**SHOP DRAWINGS
FOR
STANDARD CABINETS**

COLLEGE OF SAN MATEO (BLDG 17)

PANKOW SPECIAL PROJECTS, L.P.

*SHOP DRAWINGS PREPARED FROM
ARCHITECTURAL DRAWINGS DATED 5/15/2009*

PLAN @ WORK RM 17-118

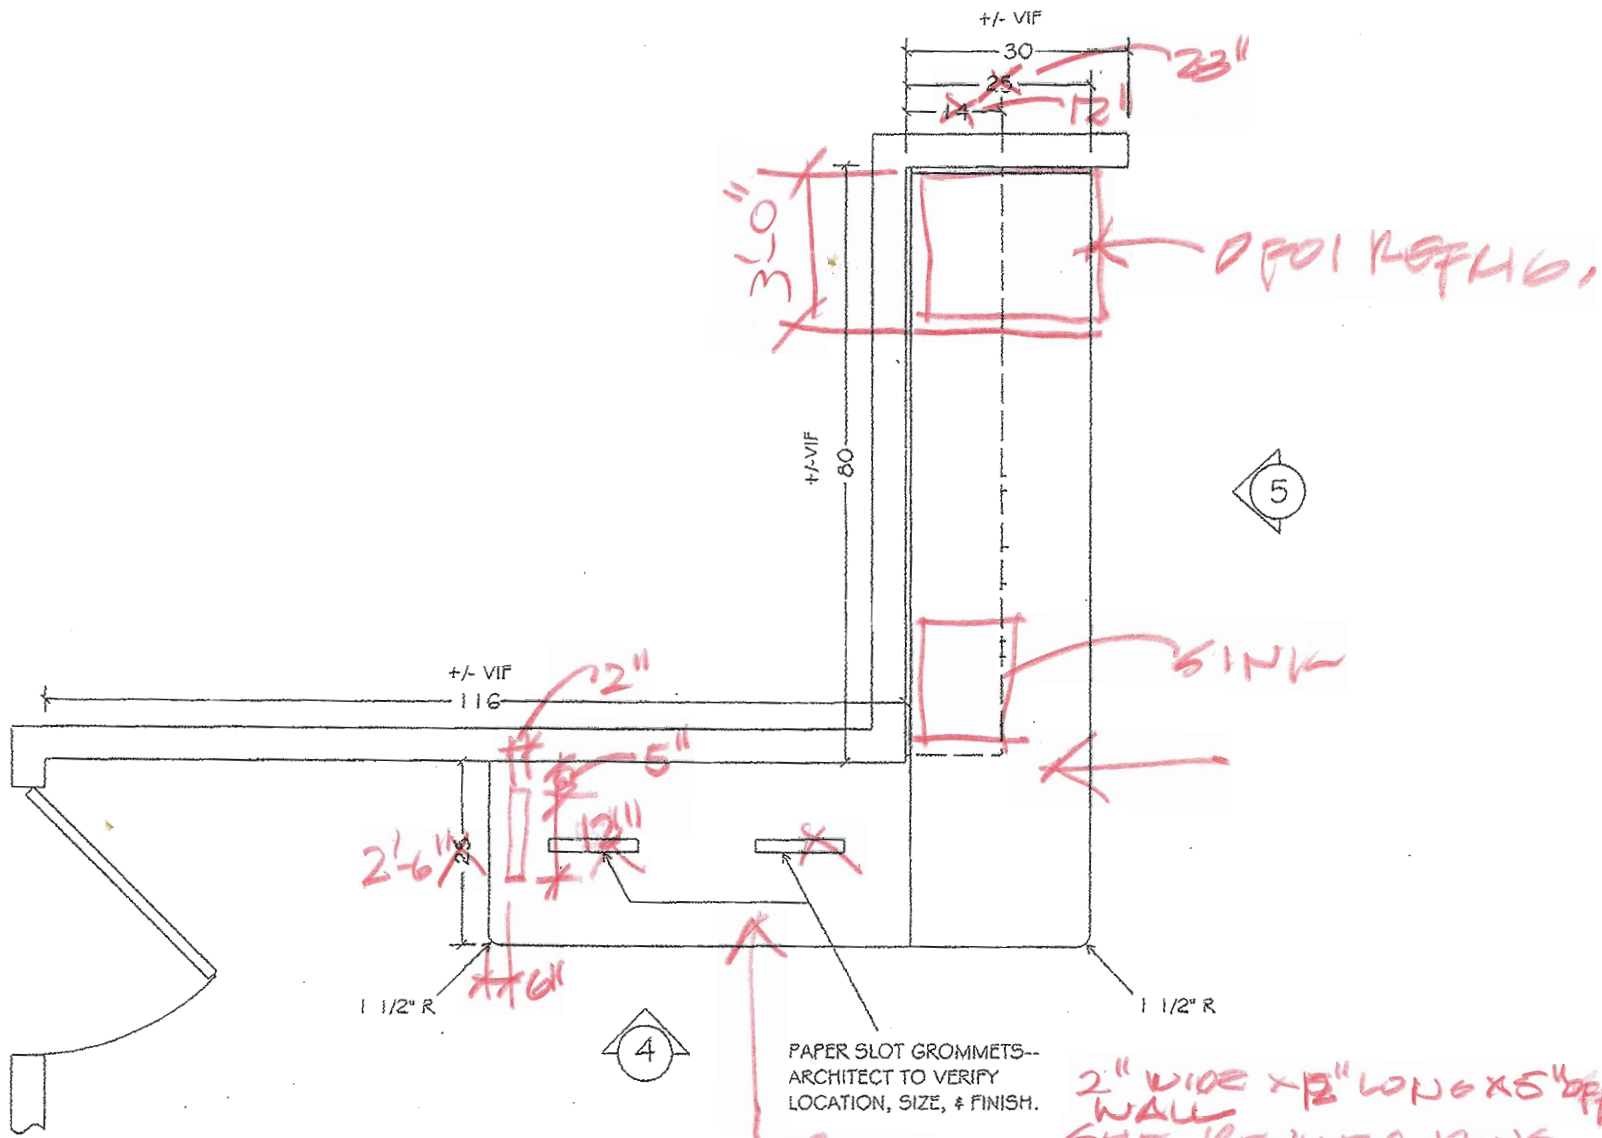
PAPER SLOT GROMMETS--
ARCHITECT TO VERIFY
LOCATION, SIZE, & FINISH.

2" WIDE x 12" LONG x 5" OFF BACK
WALL
SEE REVISED DWG
A4.22/R0-3.8

ELEVATION @ WORK RM 17-118

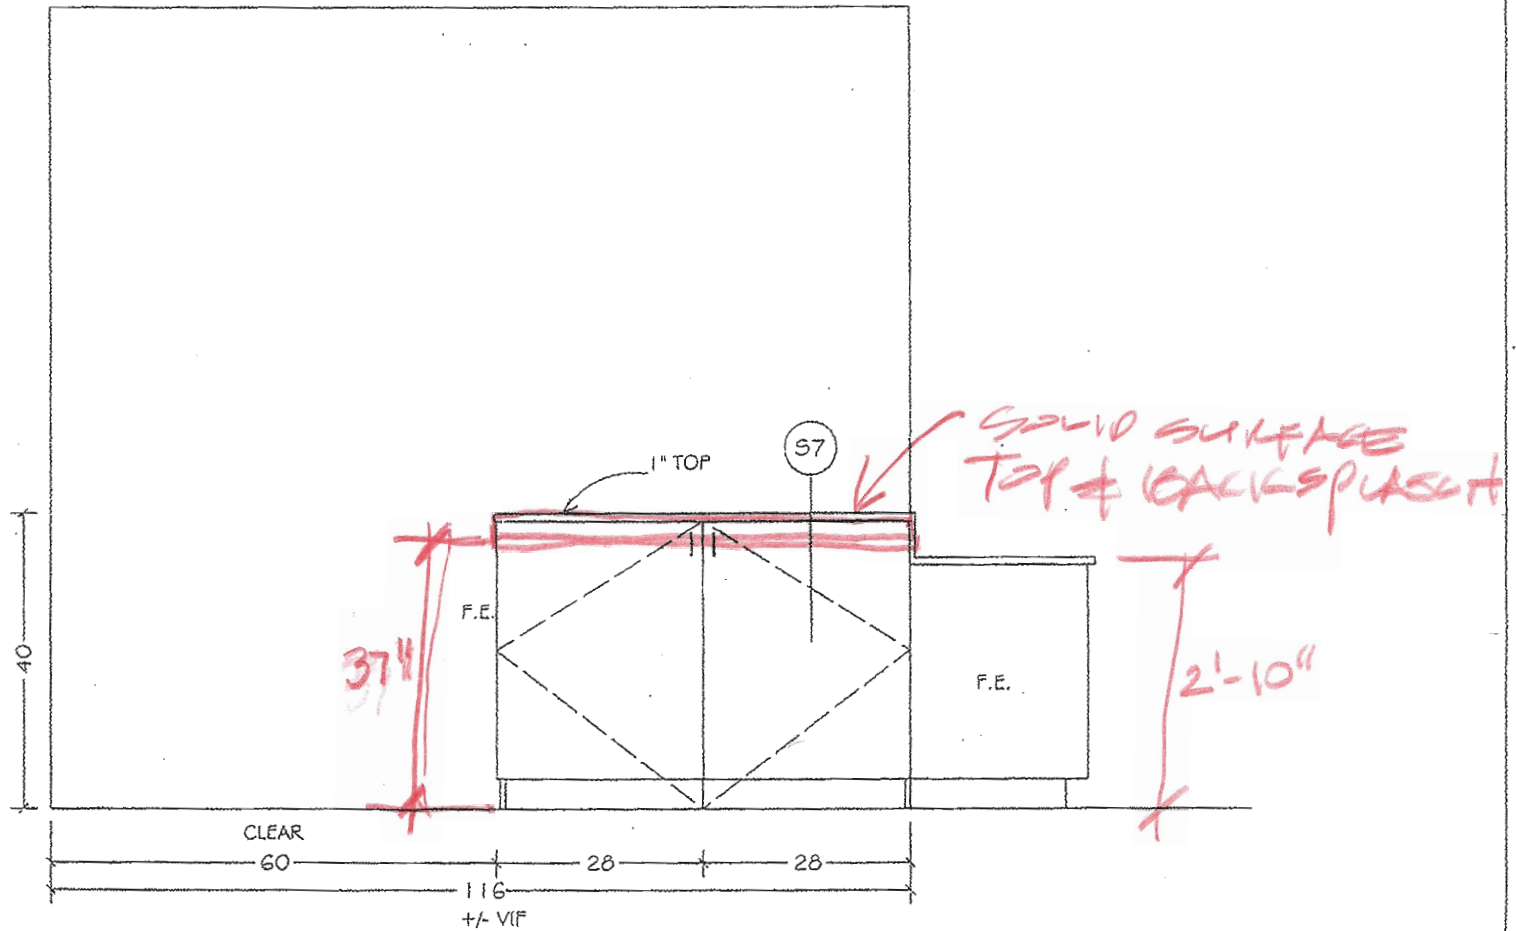
SEE DWG # A4.22/RD-3.8 FOR REVISIONS

ELEVATION @ WORK RM 17-118

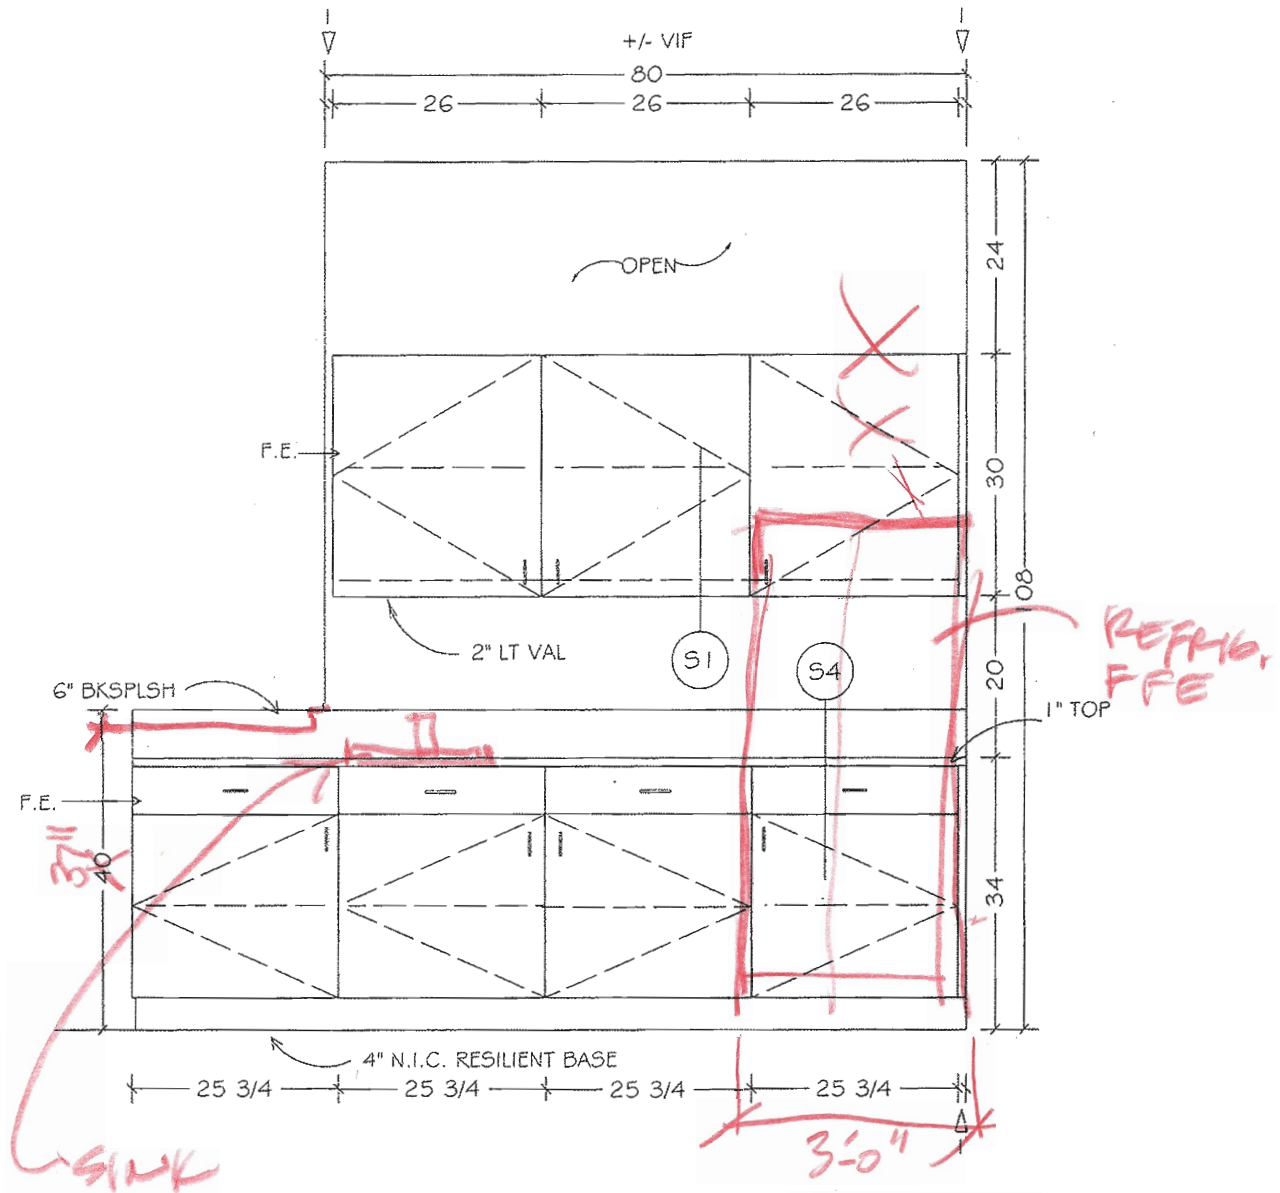
SEE DWG# 44.22/R0-3.3 FOR REVISIONS

PLAN @ ACTIVITY AREA RM 17-112

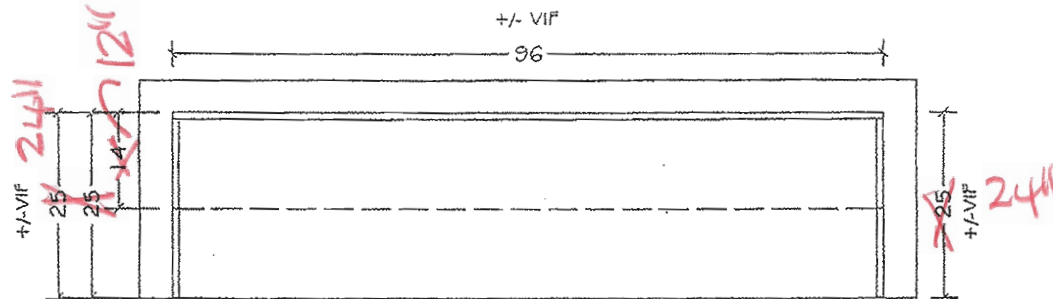
SEE DWG #A4.23/RD-3.9
FOR REVISIONS

ELEVATION @ ACTIVITY AREA RM 17-112

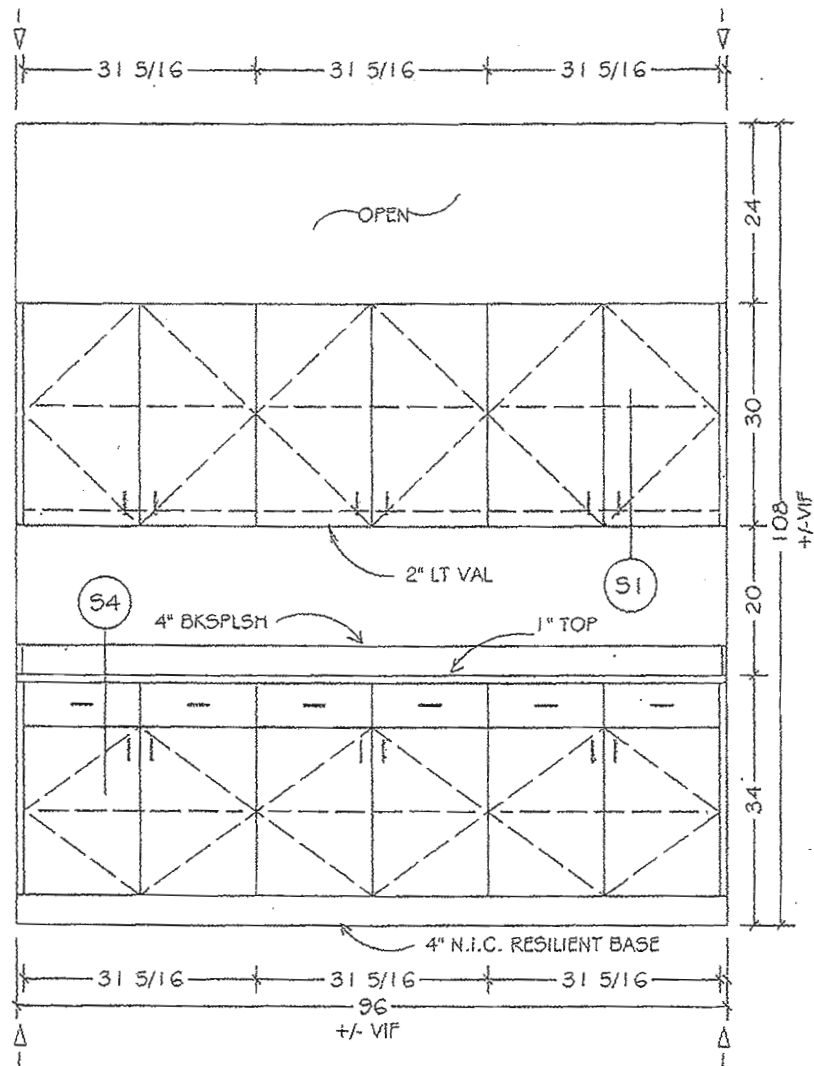
SEE DWG # A4.24/R03.10
FOR REVISIONS

ELEVATION @ ACTIVITY AREA ISLAND RM 17-112

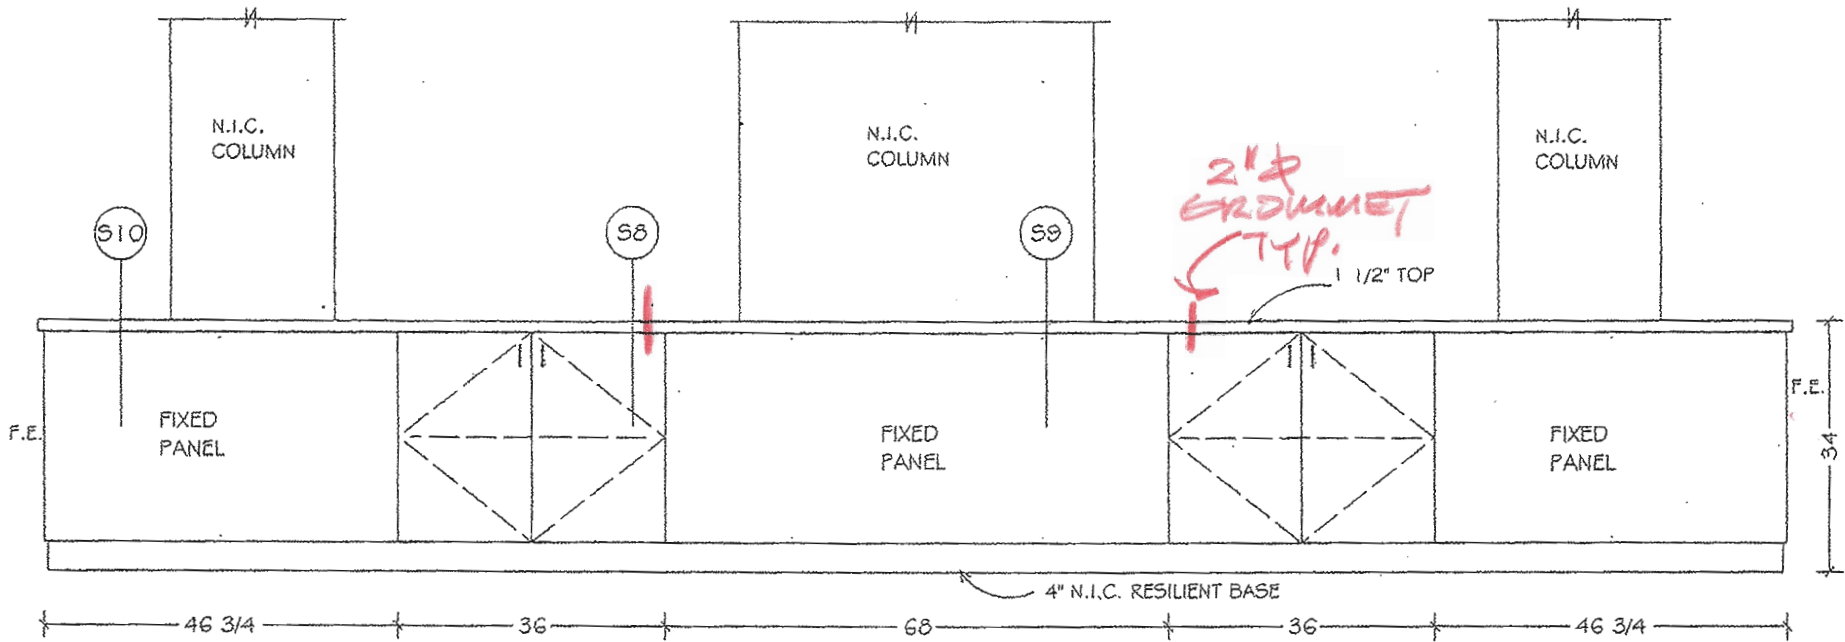
SEE DWG # 1/A4.23/K03.9
FOR REVISIONS

PLAN @ WORK RM 17-150
1/2" = 1'

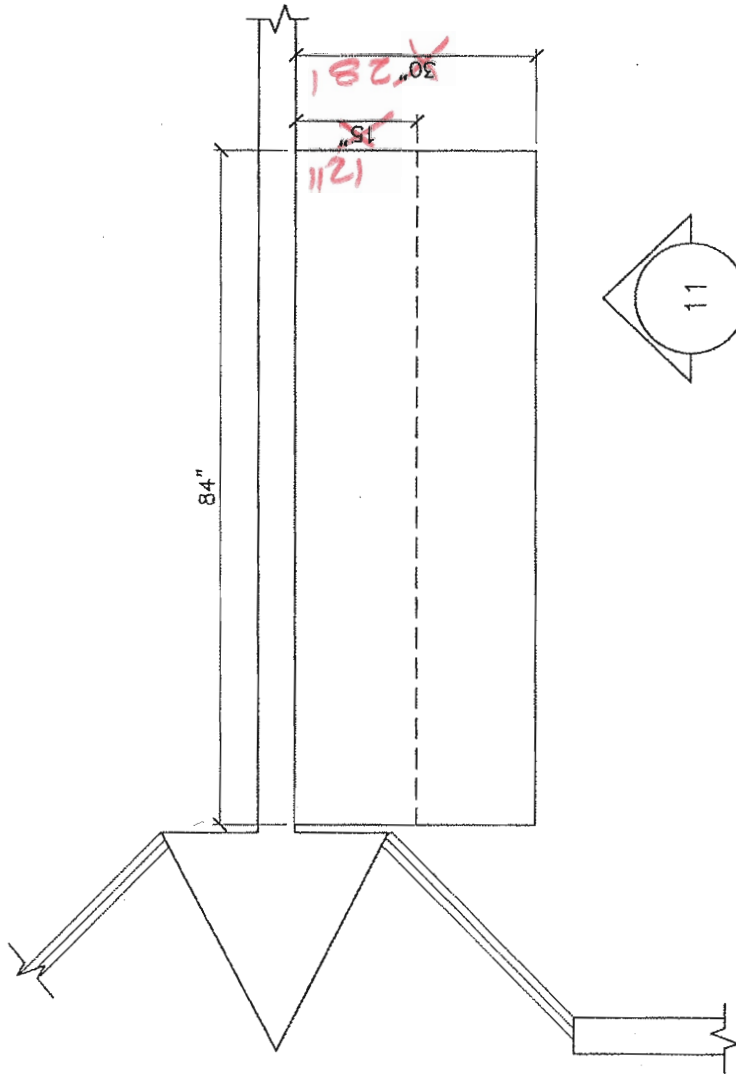
SEE DWG. # 4/A4.24/R0-3.10
FOR REVISIONS

ELEVATION @ WORK RM 17-150
 1/2" = 1'

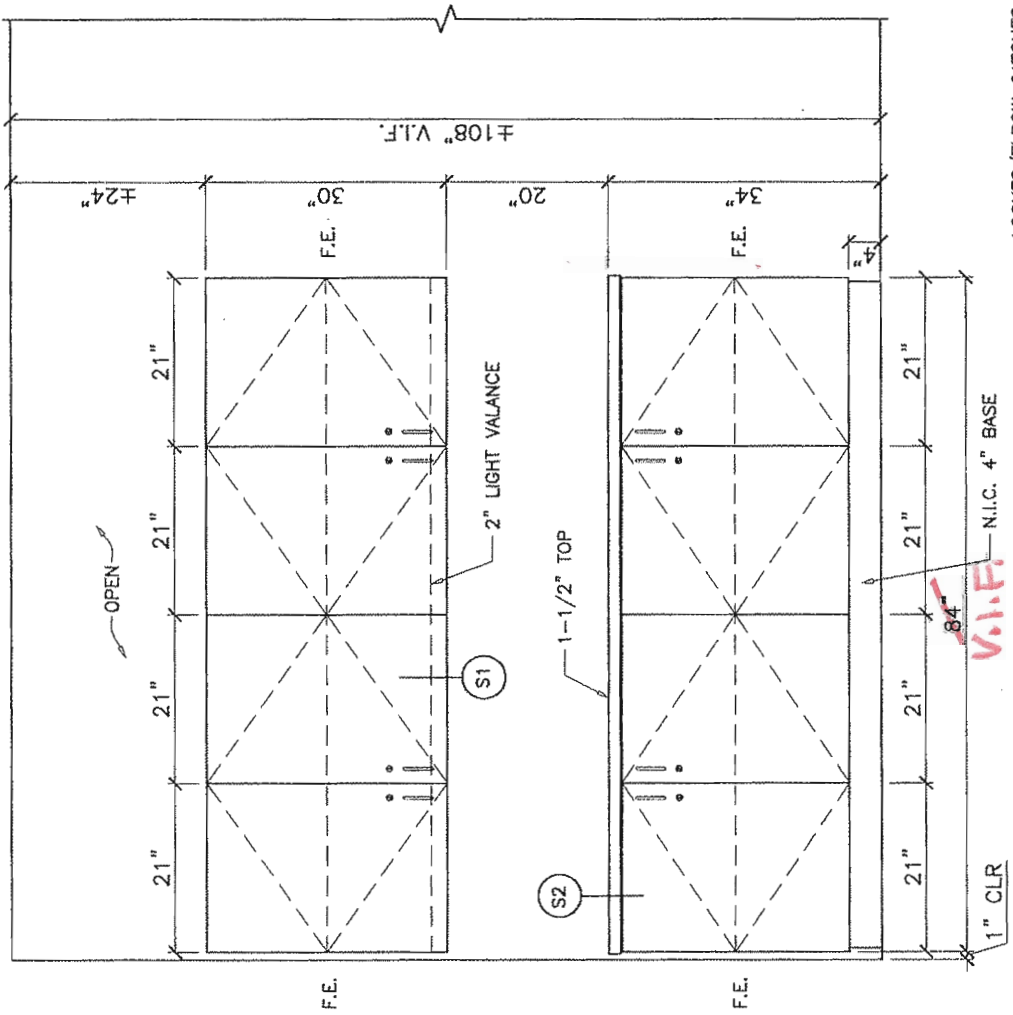
LOOKES/ELBOW CATCHES
 @ ALL DOORS

SEE DWG # 3/A4.24/R03.10
 FOR REVISIONS

52

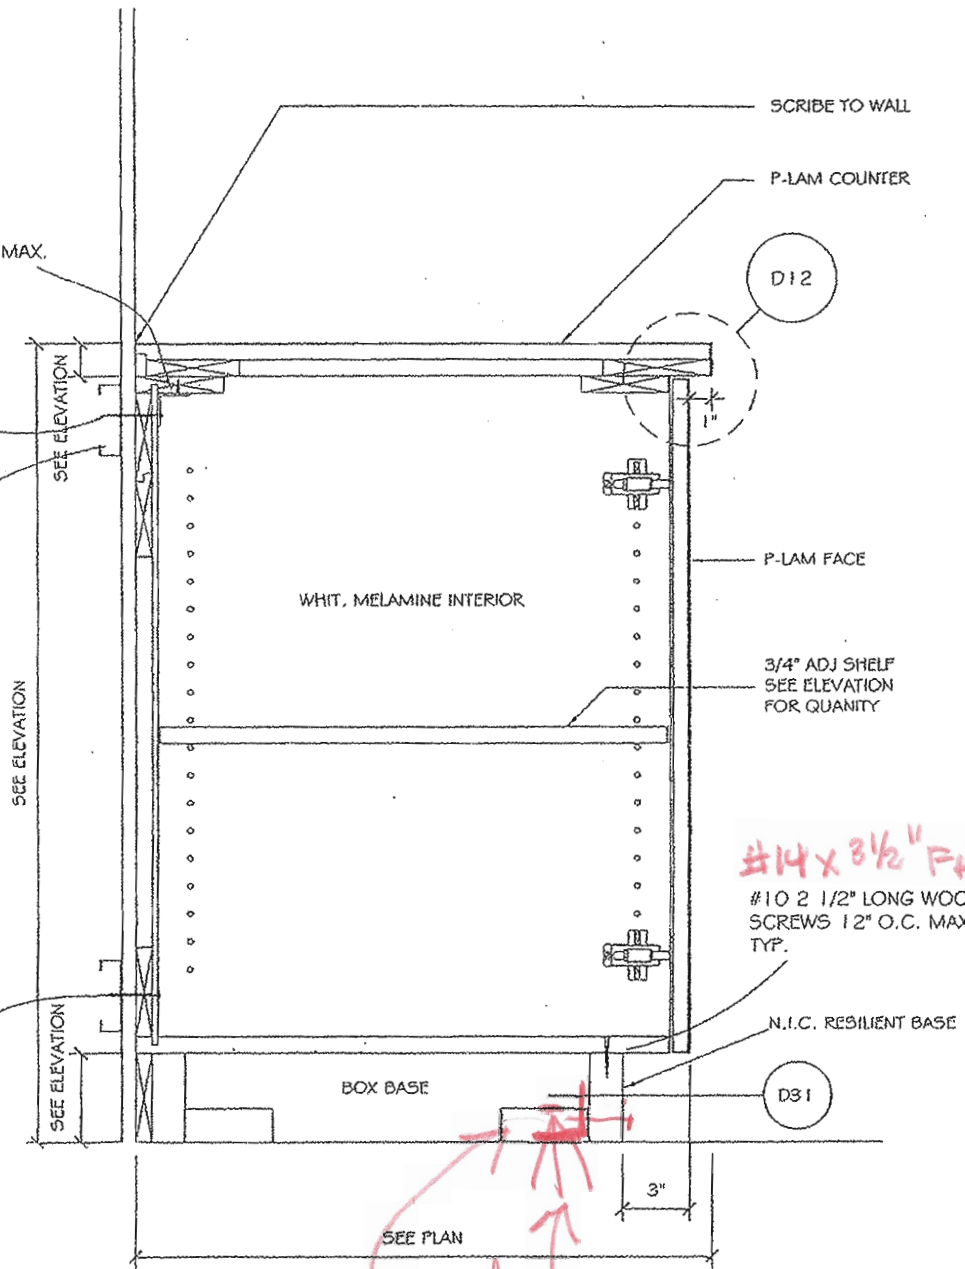
*divides
from DSA
approved
detail*

*0.145 x 1/4"
POWDER DRIVEN PIN
ANCHOR 16" O.C.
PER CABT*
